3-4-92

MB-1 Improvement Modifications

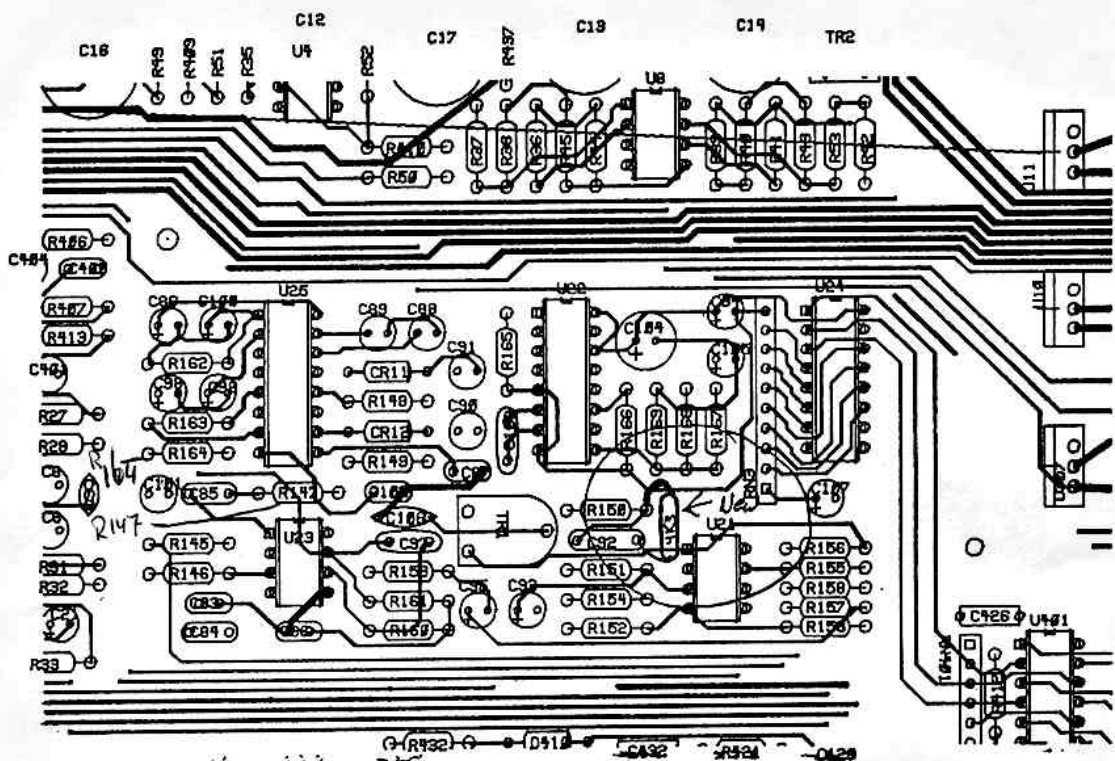
There is only 1 Component Added to The MB-1. A 4.3K $\frac{1}{4}$ w. resistor needs To be Tacked Between R150 & C92 a. Shown. Alternately, The new Resistor is connected in Parallel w C92. This component is called R170.
